MEMORANDUM

To: DRB, SB, UJFD, UCC
From: Rachel Fifield, Planning & Zoning Administrator
Date: 10/13/2015
Re: Agenda and Information for 10/19/2015

Preliminary Review
Albertini 5-lot PRD & Boundary Line Adjustment

C8-01

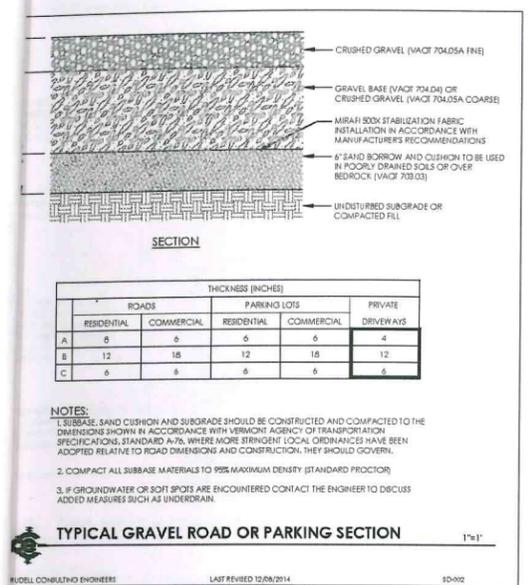
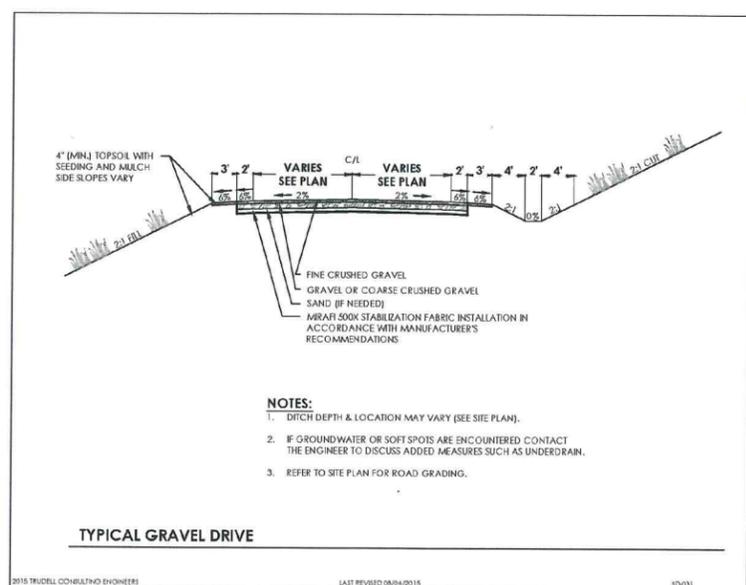
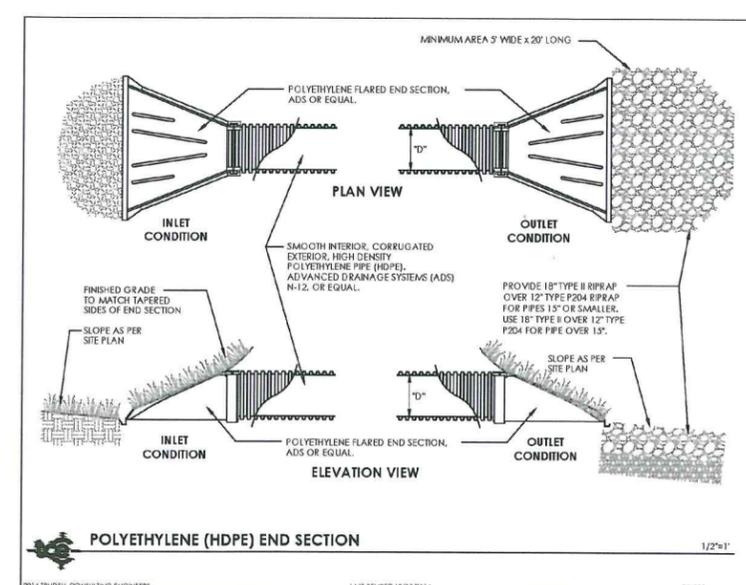
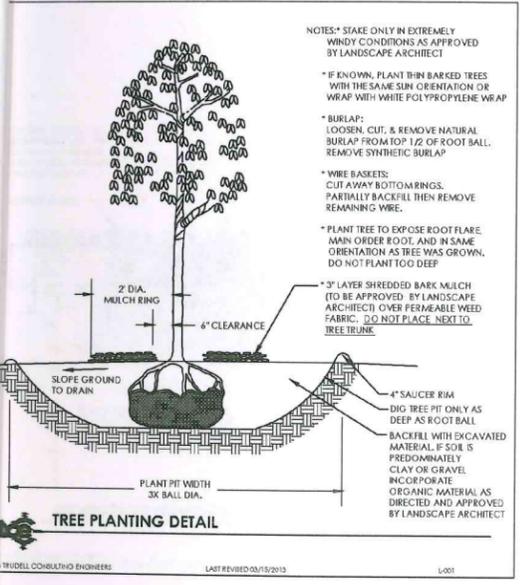
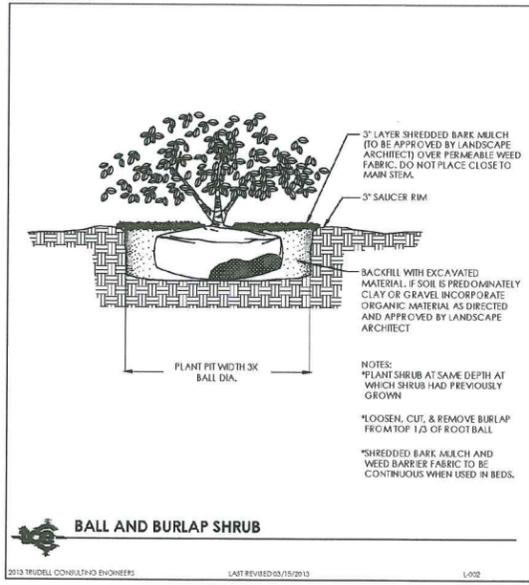
5. We presume that the typical gravel drive detail shown on Sheet C8-01 also applies to Applewood Lane. If not, a separate roadway cross-section detail should be added. The typical gravel drive detail shows a 2 ft gravel shoulder plus a 3 ft graded shoulder to the cross-slope break. The grading shown on the plans, however, do not reflect these additional widths. This should be clarified and/or corrected.

6. In the upper left corner of Sheet C8-01 is a typical gravel road or parking section. We recommend that the residential road cross-section of the far left column be used for Applewood Lane. Additionally, who decides where the 6" of sand borrow (layer "C") is needed? If provided over poorly drained soils, the sand borrow needs to daylight to roadside swales in order to be effective (the typical gravel drive detail to the right shows a box cut). Being a private road, how much construction oversight will be provided? The placement of the geotextile stabilization fabric differs in the two details (one is above the sand and the other is beneath the sand).
